City of Rockport

CITY COUNCIL REGULAR MEETING AGENDA

18. Consider the approval of Construction Change Directive #4 related to the new City Hall project

Consider the approval of Construction Change Directive #5 with Teal Construction related to the new City Hall project (cost pending)

Description: RFI 156.1 Shades

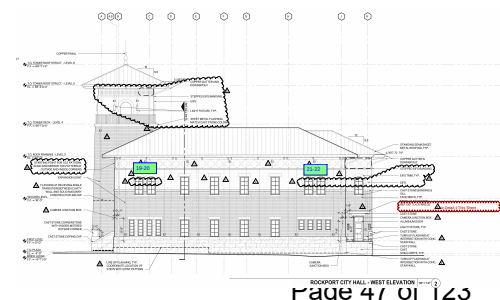
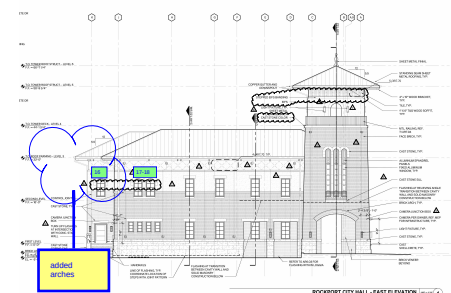
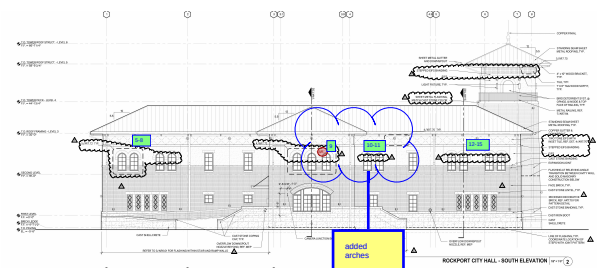
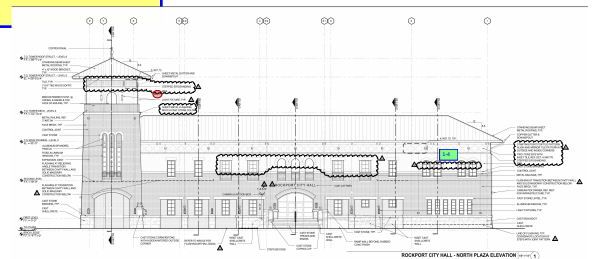
- 46 single shades (see plan attached)
- 4 single shades added at Break Room

- 26 Dual Shade = 52 shade bands (see plan attached)
- 1 added at Jury Room
- 4 dual shades deleted at Multi-purpose

- Counted 22 by PGAL
- 4 were added at Break Room,
- 6 were deleted at Tower
- Arches should be covered as part of the base bid

RFI 0168 - G window

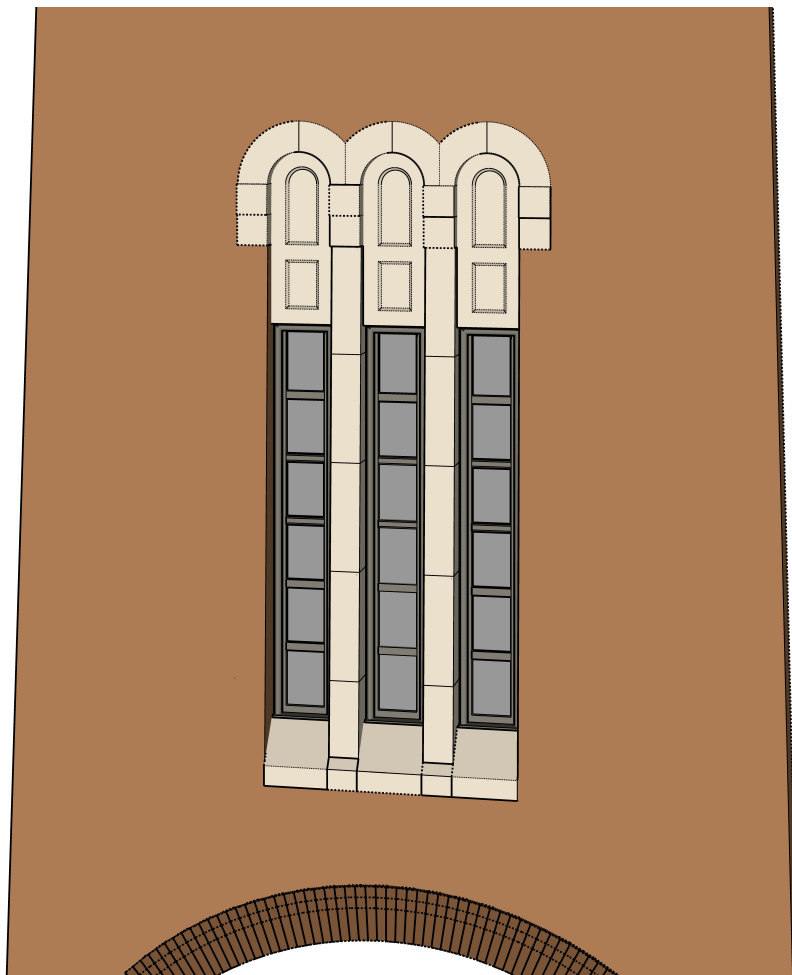
- Question added:
Please advise on radius design for the g windows.
Larry irsik gave recommendations to teal, teal took profile trim to the vendors and not capable of doing profile.
Please advise on design
email was sent to design team
- Title added:G window
- Submitter added:Heaven Vasquez (Teal Construction)
- Manager added:Giang Phan (PGAL)

Provide EIFS infill with recessed panel detailing within arched openings above tower windows. Refer to attached revised SK-3A, SK-3B, SK-3C, SK-3D, and new SK-3E.

1. Verify as-built conditions and dimensions before proceeding. Verify as-built location of Type G window frames within exterior walls and in relation to brick and cast stone jambs. If location differs from dimensions shown on SK-3A through 3E inform the Architect.
2. Delegated design metal framing required at window heads and infill area above windows.
3. Resolve cast stone steel support detail before proceeding with work.
4. EIFS infill panel finish and color to match cast stone. Steps at inset panel areas must be crisp and accurate. Provide EIFS color samples for selection: SW 7518 Beach House and SW 7713 Tawny Tan.
5. Teal/G&B to provide sketch for waterproofing details at transitions from exterior wall Tremco liquid applied system to the Parex EIFS system.

SHEET TITLE
TOWER WALL
SECTIONS

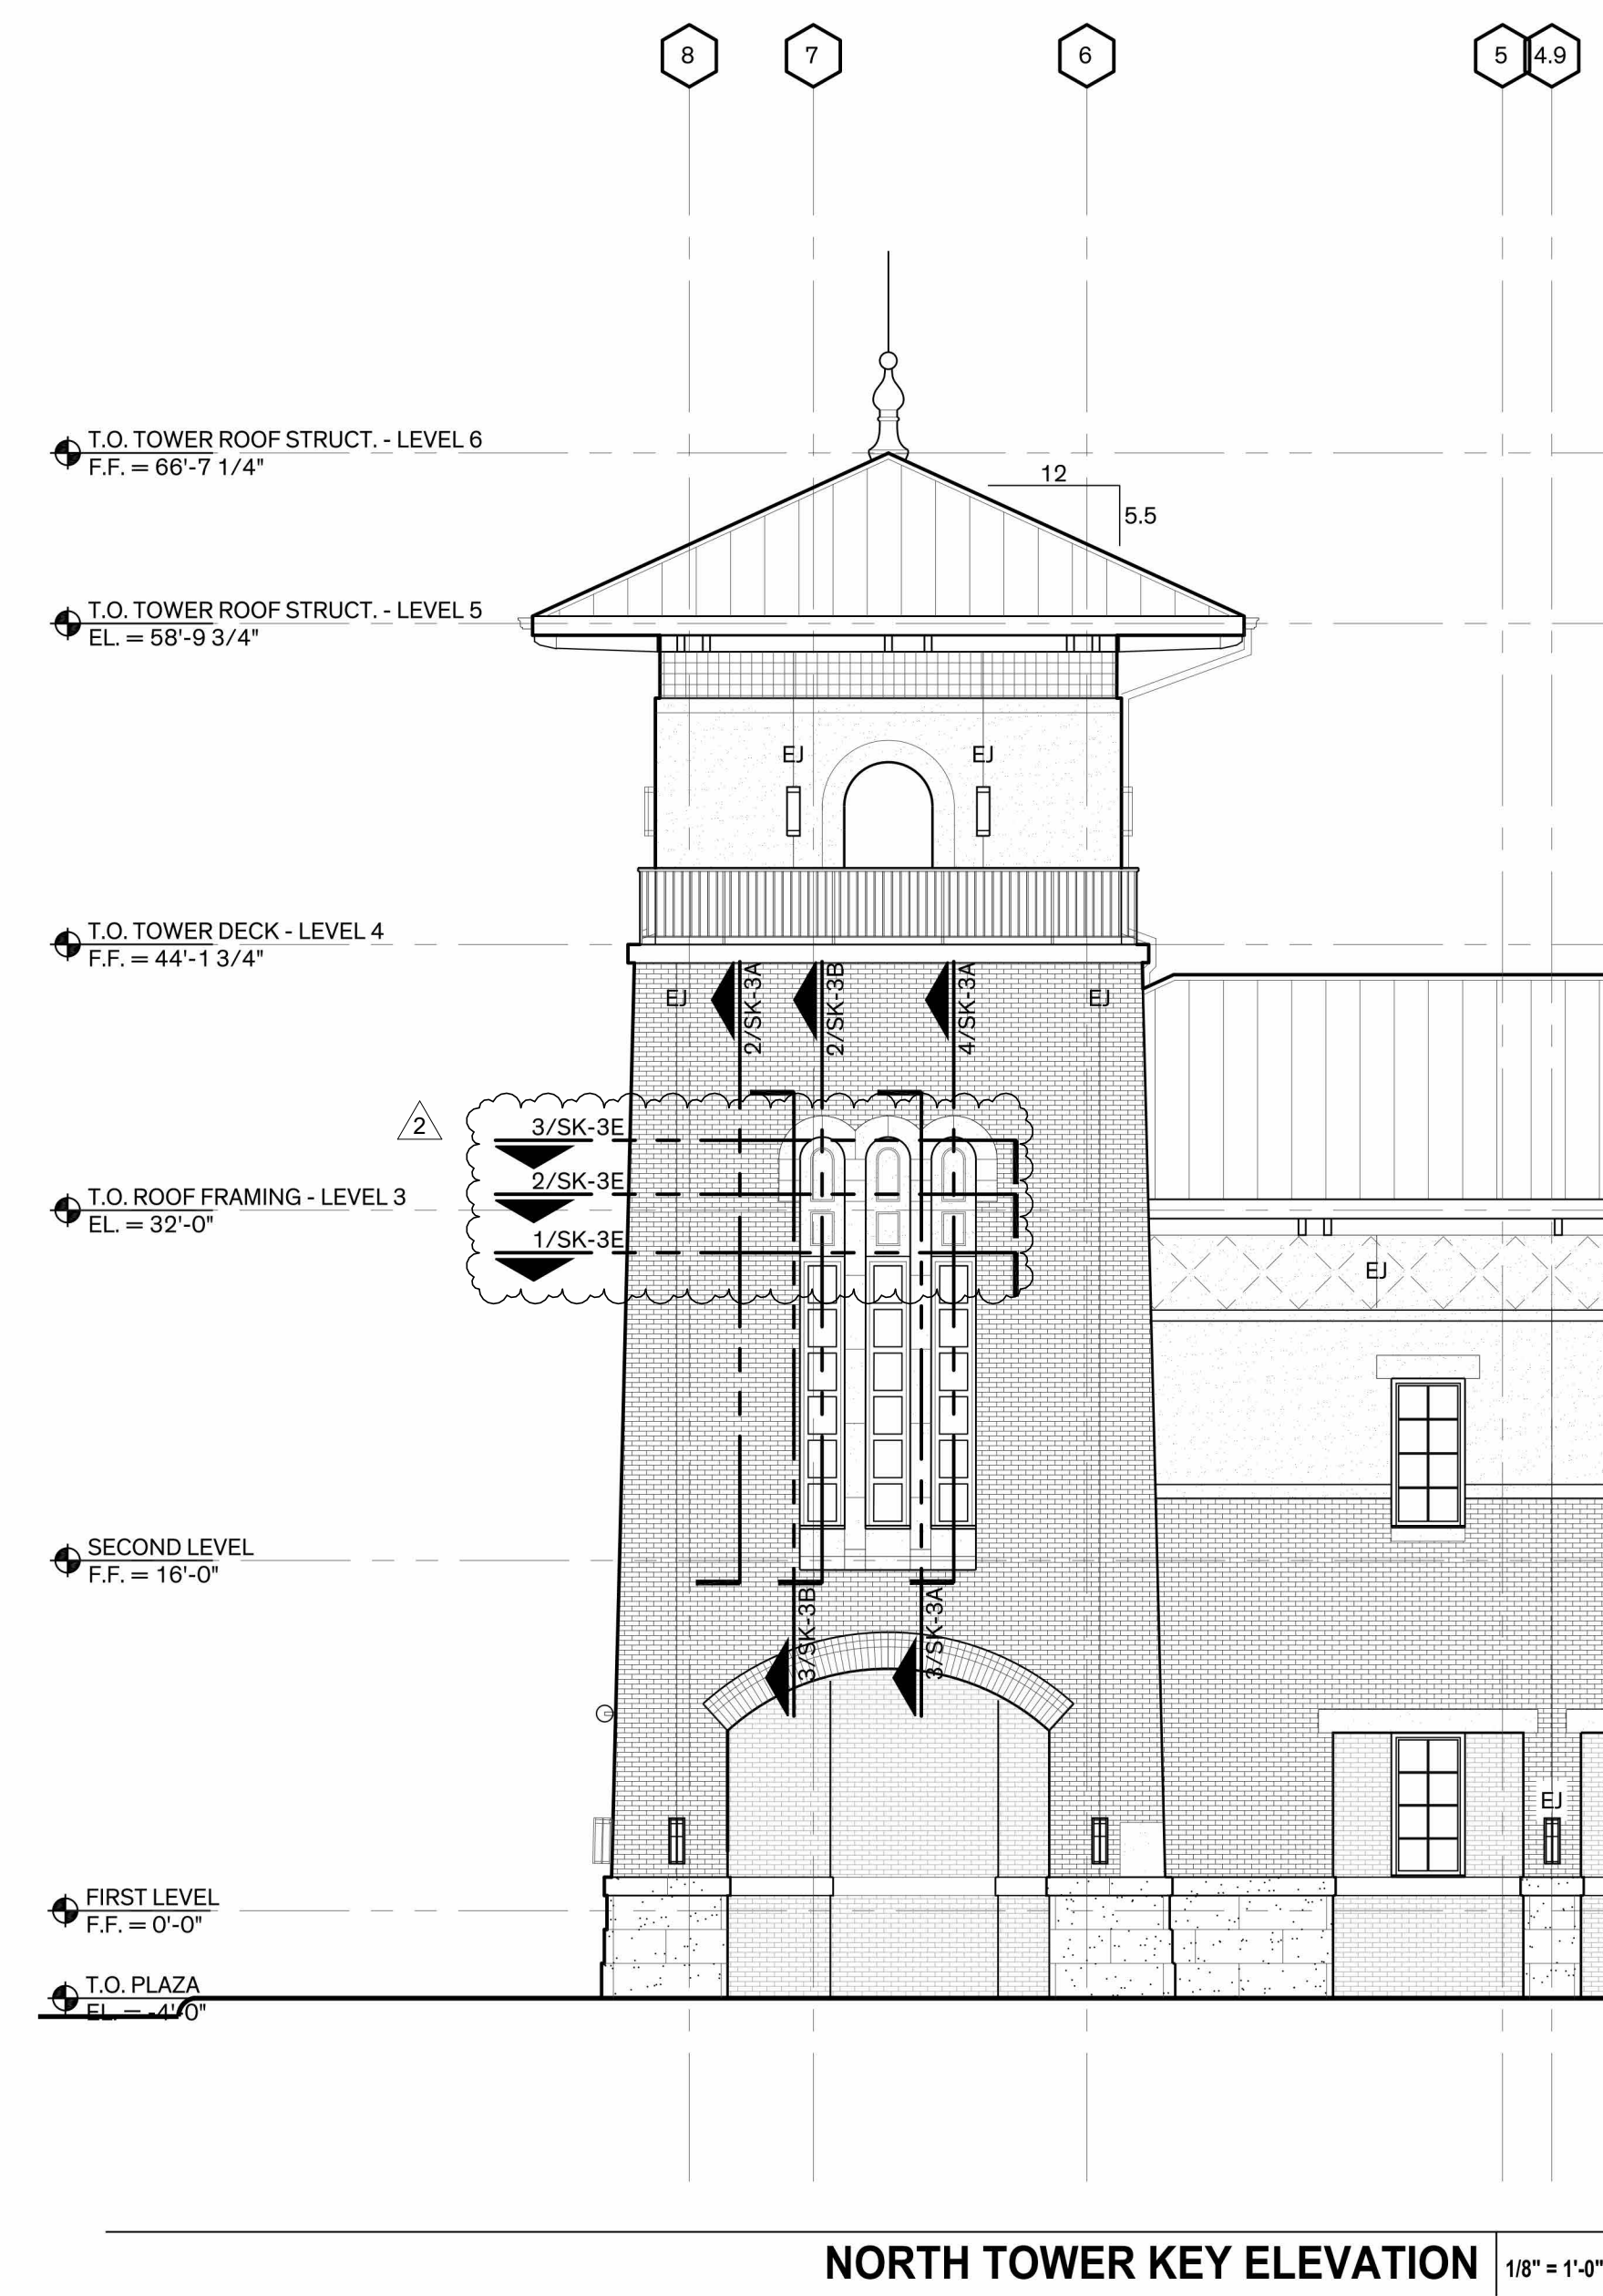
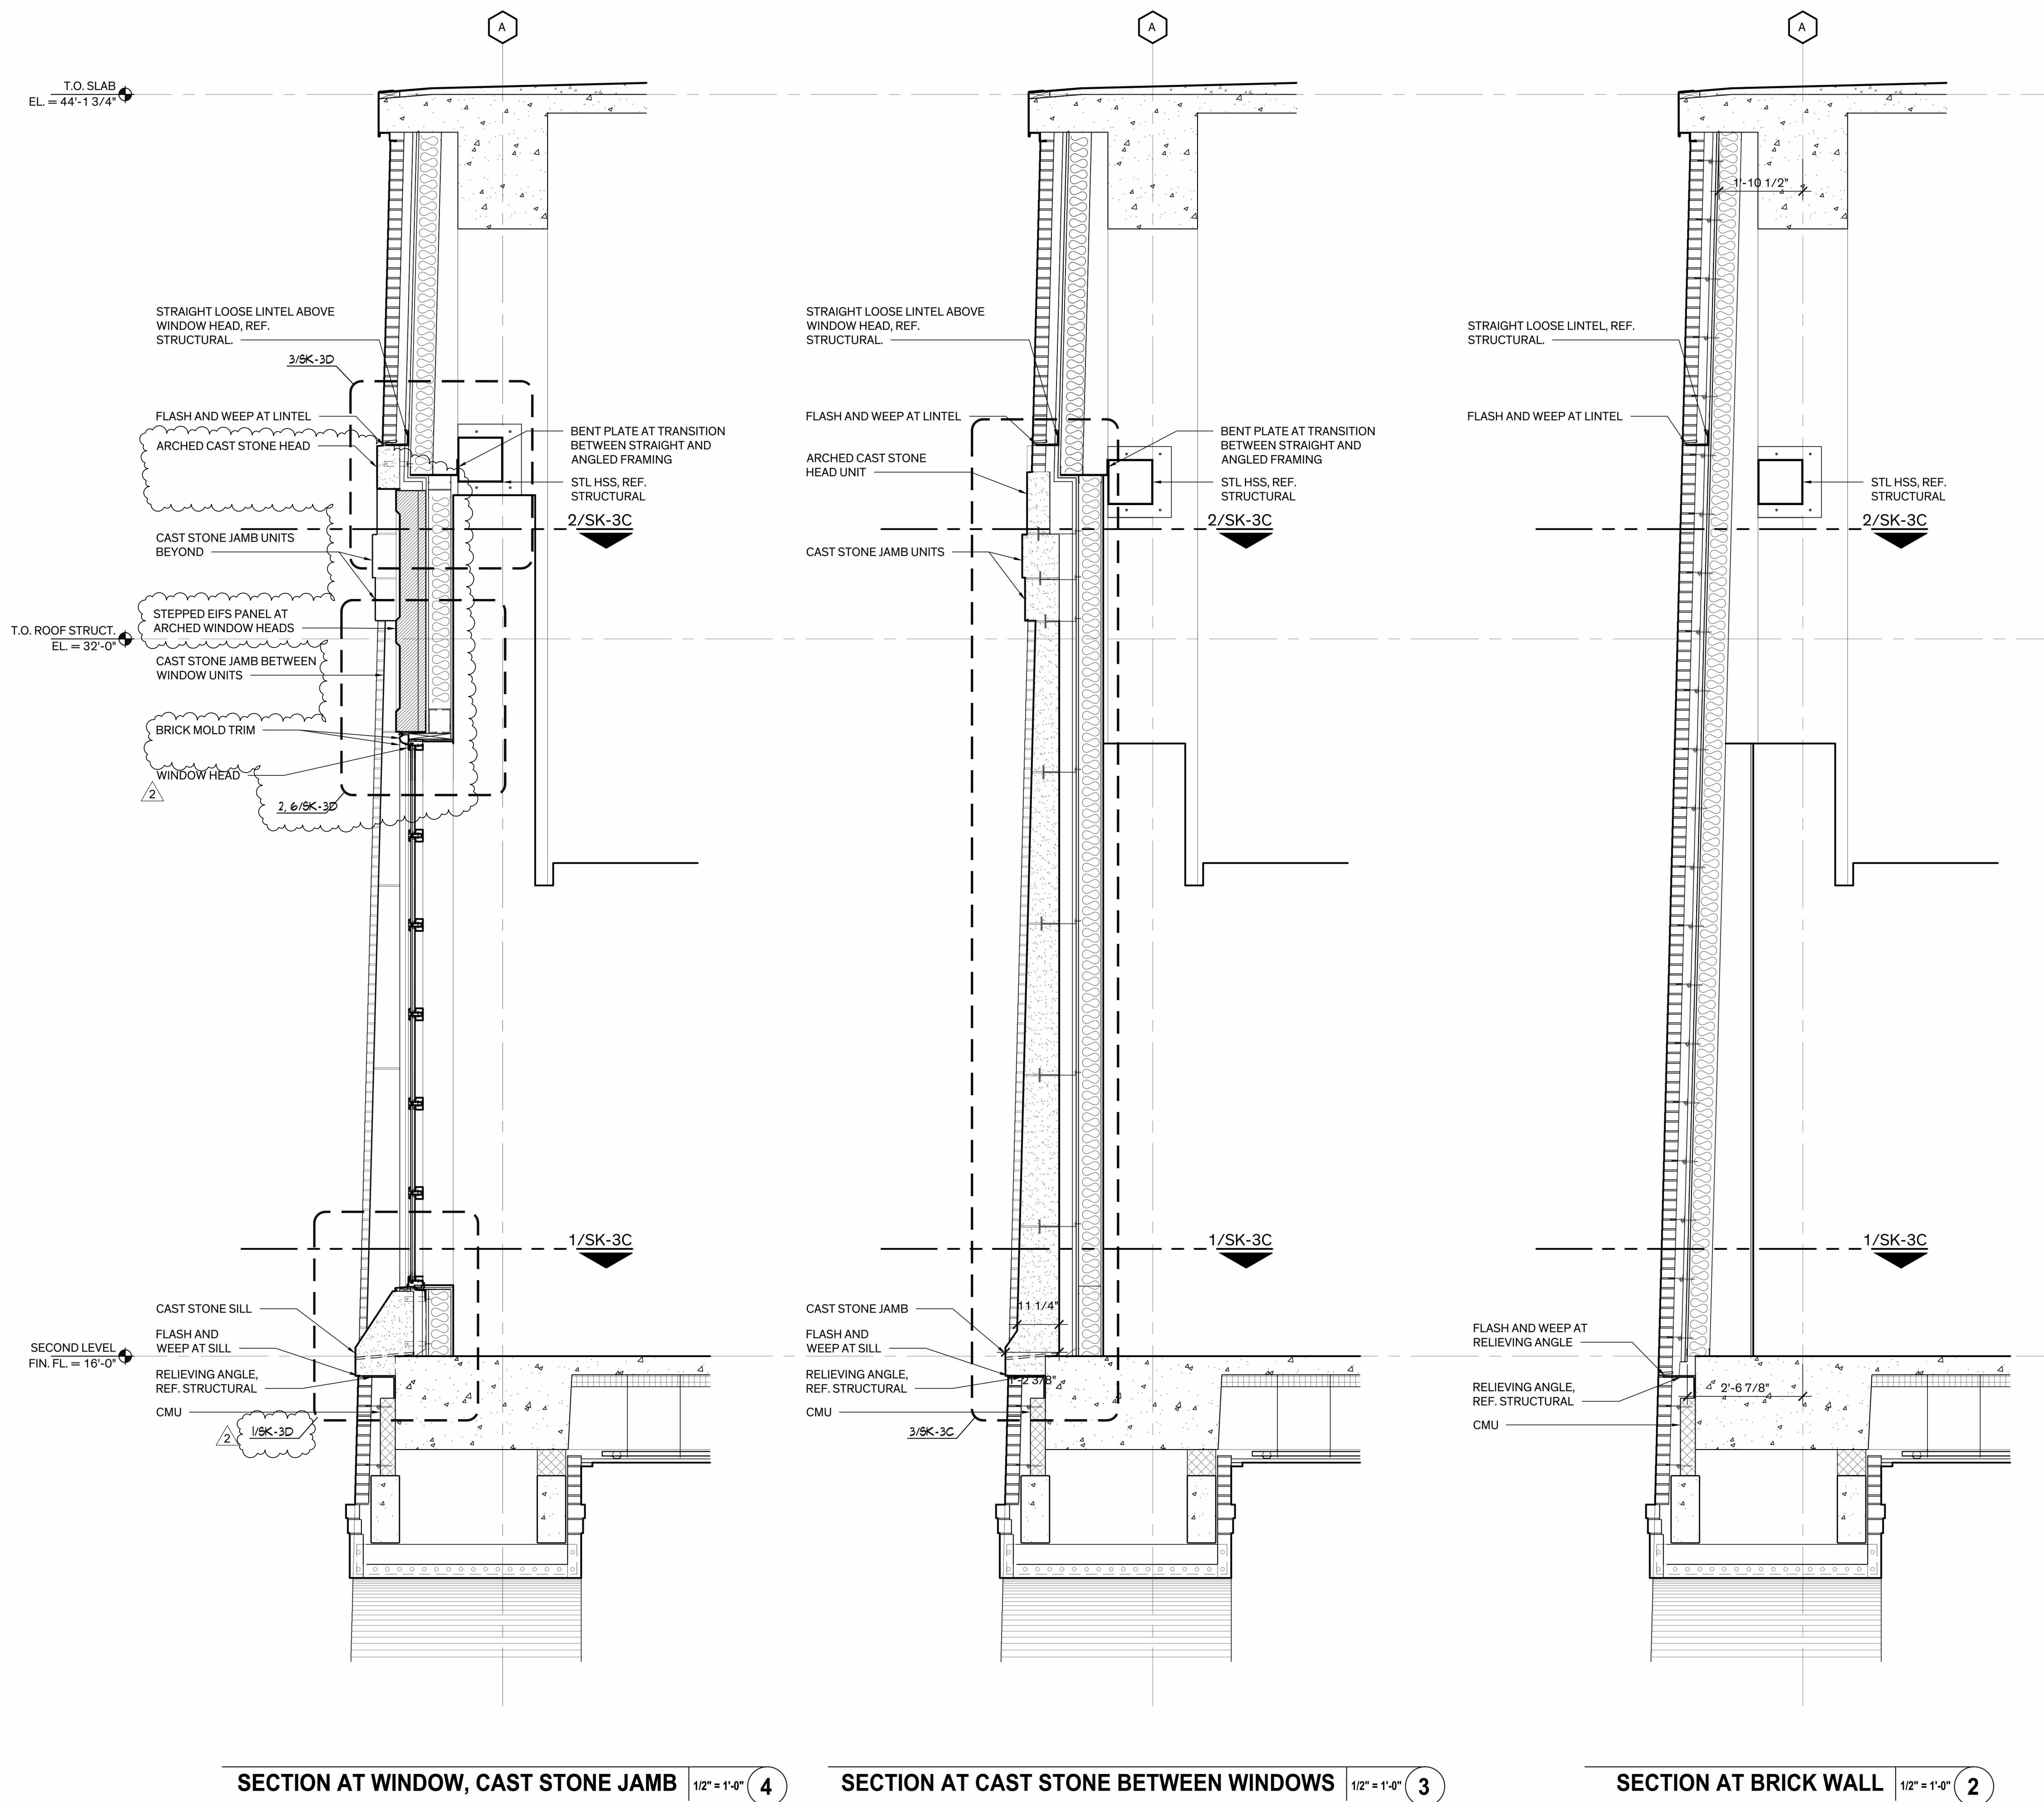
-Teal did not coordinate the infill panels designed for the area above the rectangular windows (SK-1 provided 11/22/22 with window shop drawing review) and sequencing of surrounding construction. Infill panels needed to be coordinated prior to proceeding with waterproofing and finished masonry openings. Teal is responsible for all masonry removal and reinstallation required in this change request.
